AMENDMENT 2
AMENDEMENT 2

**Medical electrical equipment –
Part 2-33: Particular requirements for the safety of magnetic resonance
equipment for medical diagnosis**

AMENDMENT 2
AMENDEMENT 2

This amendment has been prepared by subcommittee 62B: Medical imaging equipment, of IEC Technical Committee 62: Electrical equipment in medical practice.

Figure 107 – Determination of the spatial maximum of the gradient output

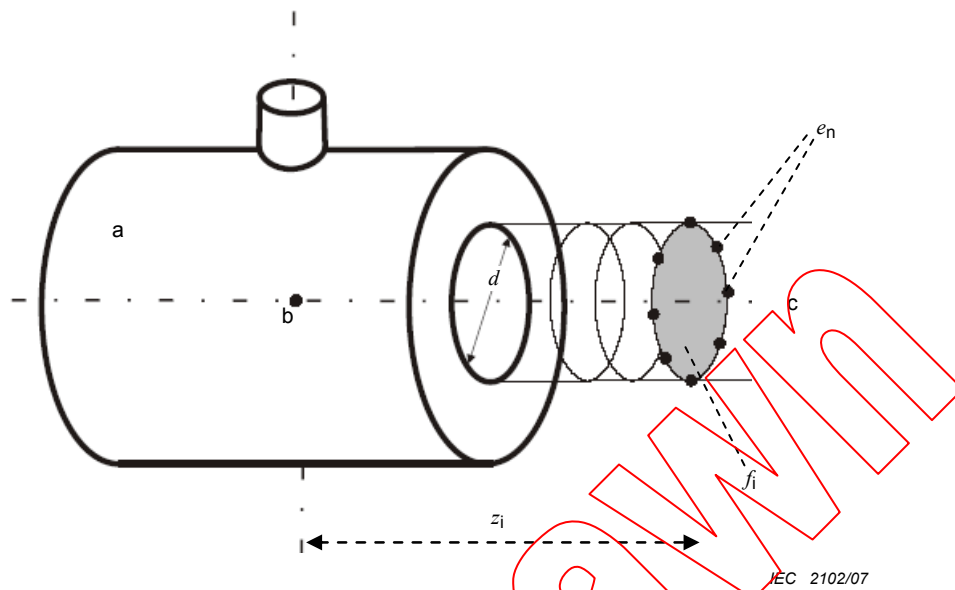
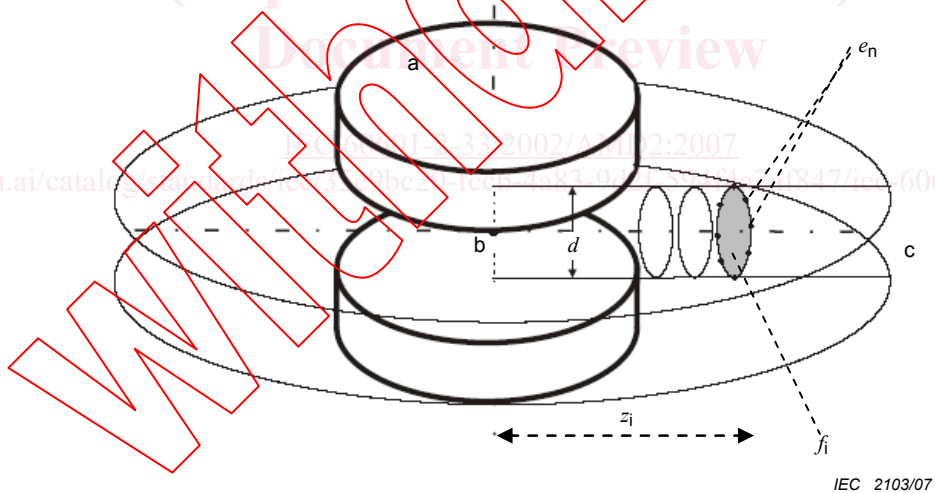
Add, on page 73, a new subclause 51.105.2.3 before 51.105.3:

51.105.2.3 Determination of the GRADIENT OUTPUT stray field as required for reporting in 6.8.3 bb.

To be able to estimate the exposure for MR WORKERS, for each GRADIENT UNIT the spatial maximum of the GRADIENT OUTPUT shall be determined in an extended COMPLIANCE VOLUME, see Figures 107a and 107b. The specific point pattern shall represent worst-case locations where the MR WORKER has access to and can be maximally exposed by the GRADIENT UNIT.

- The specific point pattern shall be located on a virtual cylinder surrounding the PATIENT axis with a diameter equal to the minimum accessible PATIENT bore.

- The cylinder starts at the magnet isocentre and exceeds the PATIENT bore opening (half the magnet length) by at least 0,5 m.
- In the cylinder axis direction the points shall have a separation of not more than 0,1 m.

- For each cylinder axis position at least 16 points shall be equidistantly spaced on the cylinder surface (i.e. on a circle). The points shall include those located half way between the x and y gradient axes (i.e. $n \times 45^\circ$, $n = 1,3,5,7$).

- The magnetic field vector for each GRADIENT OUTPUT shall be calculated using the law of Biot-Savart or measured for each point on the cylinder.
- For each point the three FIELD vectors shall be summed and then the field magnitude shall be determined.

- This maximum magnitude values shall be plotted along the cylinder axis position. The axial position of the PATIENT bore opening shall be marked.
